# 1984 - 1985 Corvette: Service Bulletin: Noise in Direct Drive 4-Speed Manual Transmission

**Source:** Chevrolet Dealer Service Bulletin

**Bulletin No:** 85-111

**Figure 1**

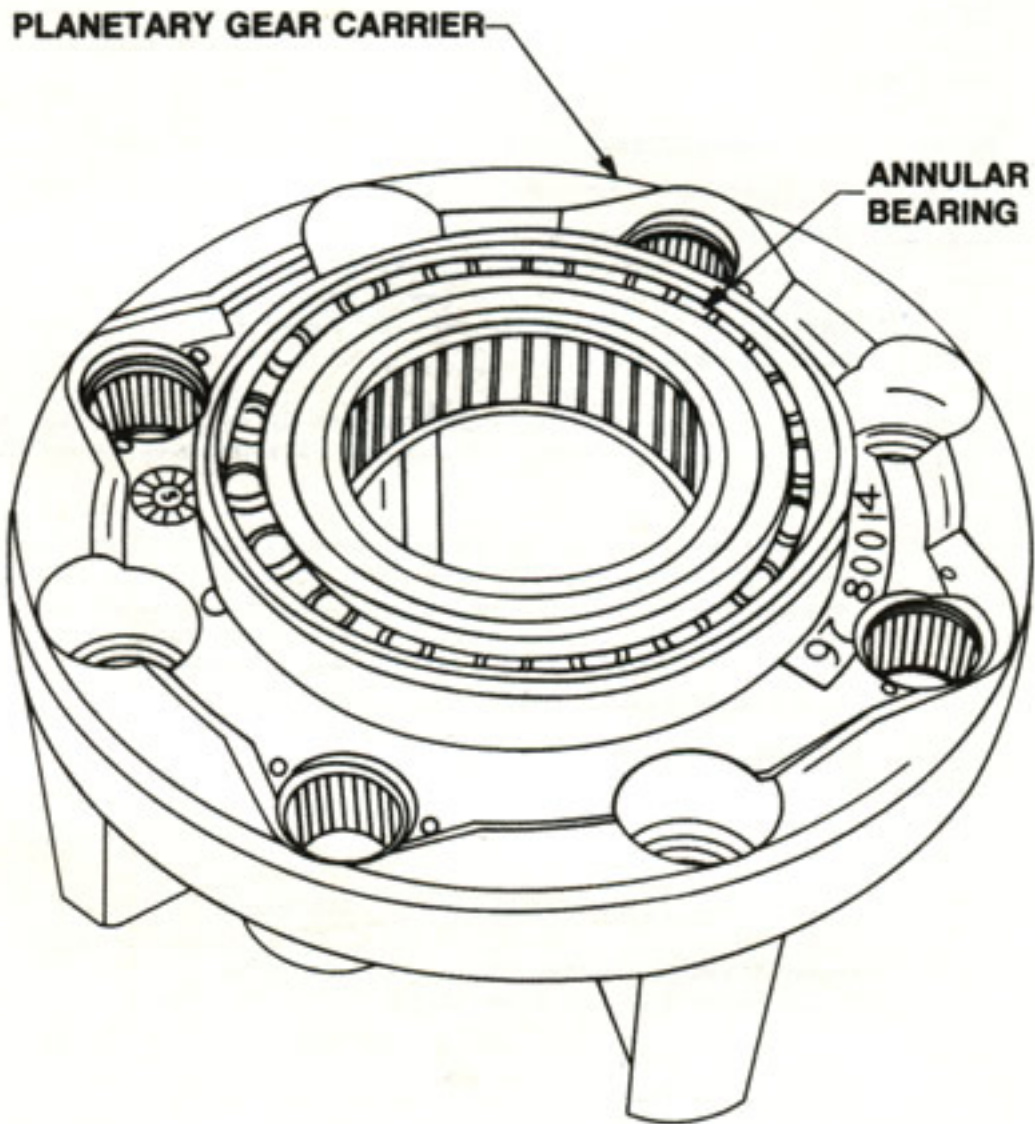
This condition may be caused by a worn annular bearing on the planetary gear carrier (see illustration). Continued operation of a noisy transmission in the direct drive model will cause damage to the planetary carrier, adapter plate, input sun gear, and input sun gear oil seal. If the input sun gear oil seal is damaged, it is possible for overdrive unit oil (Dexron II) to leak into the manual portion of the transmission.

On transmissions beginning with serial number D5C 14413 CF, a new planetary gear carrier has been released. This carrier (P/N 14094571) incorporates an annular bearing with increased thrust capacity.

1. Inspect the adapter plate surface, input sun gear, and input sun gear oil seal for damage. If there is indication of damage, the adapter plate, input sun gear, and input sun gear oil seal should be replaced. If there is no sign of damage, these parts may be reused.
2. If debris is present in the overdrive unit, completely disassemble and clean the unit, including the valve body. Thoroughly flush the cooler lines to remove any debris following the procedure outlined in the Vehicle Service Manual. Replace the oil filter.
3. If there is evidence of oil intrusion from the automatic overdrive unit into the 4-speed manual unit, the manual unit should be drained and flushed also.
4. Replace the planetary gear carrier with the new, P/N 14094571, carrier.

**NOTICE:** When an overdrive unit from a transmission built prior to serial number D5C 14413 CF is disassembled for any reason, it is recommended that a new, P/N 14094571, planetary gear carrier be installed to prevent potential future annular bearing failures.
